**RHODE ISLAND
STATE BUILDING CODE**

SBC-2 Rhode Island One and Two Family Dwelling Code

Effective August 1, 2007
Replaces Existing Regulation SBC-2-2004
Dated July 1, 2004

Figure 301.2 (4) (A)

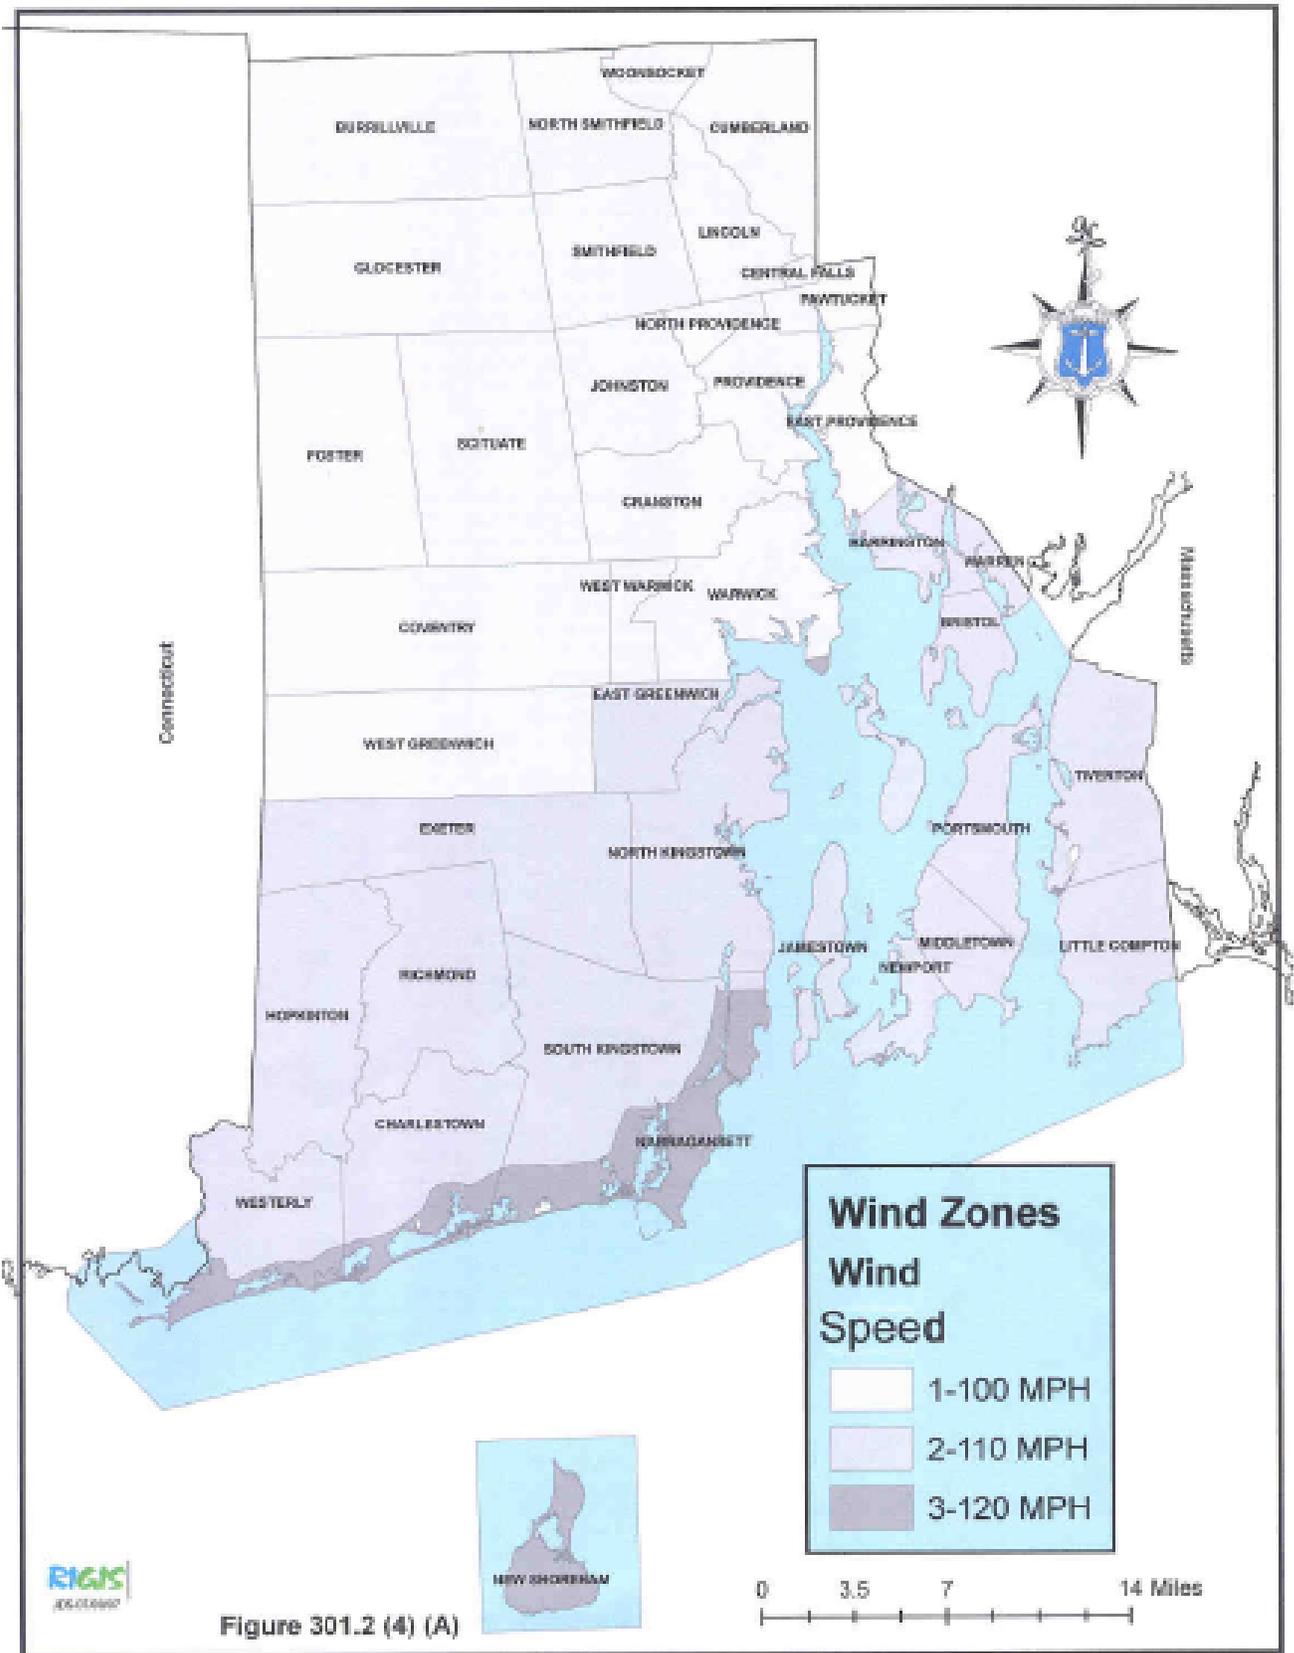
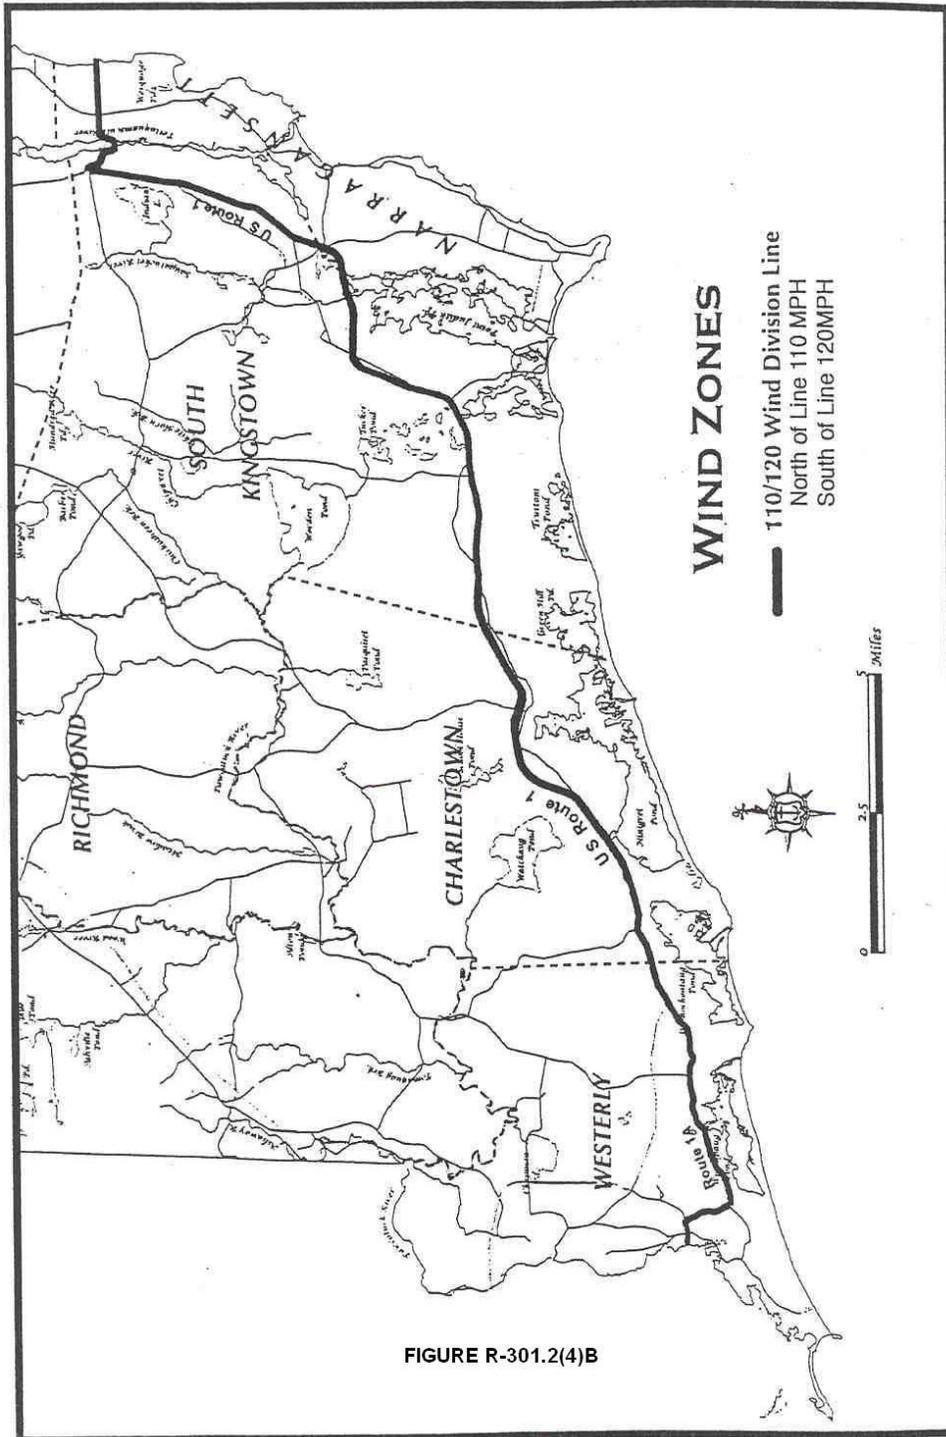
Delete IRC Figures R301.2(4) and substitute the following

Figure 1102A

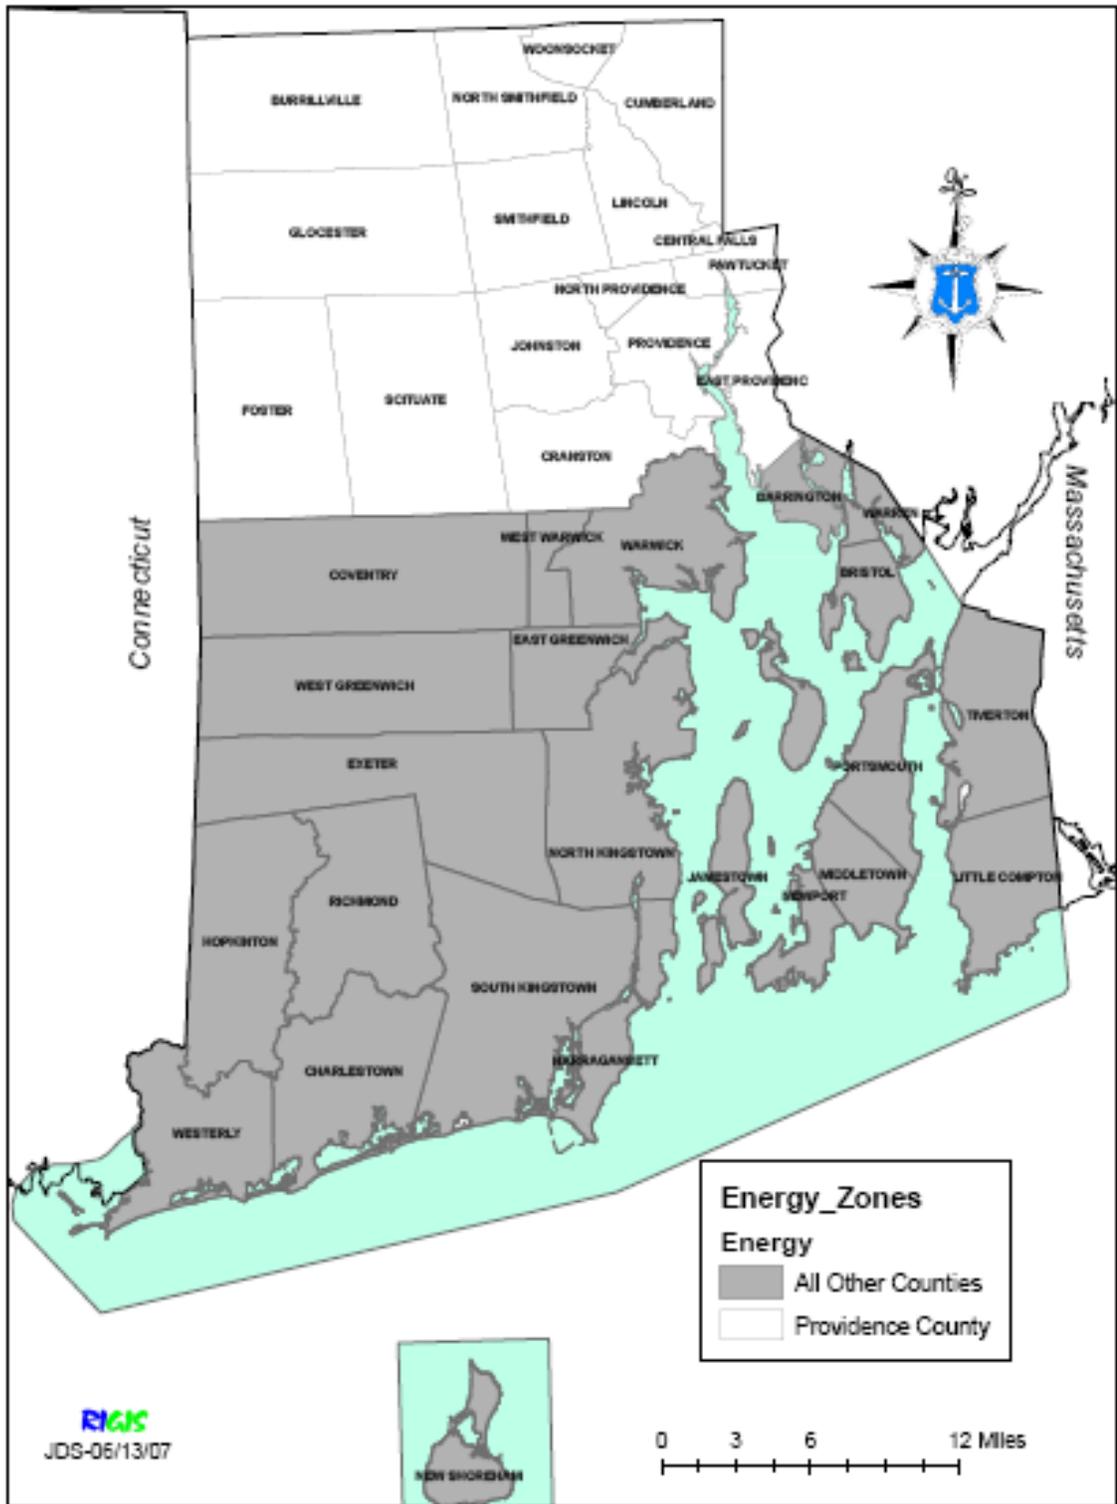
| Add the following Table | | |
| Table 1102 Exterior Design Conditions. See Figure 1102 A | Value | Value |
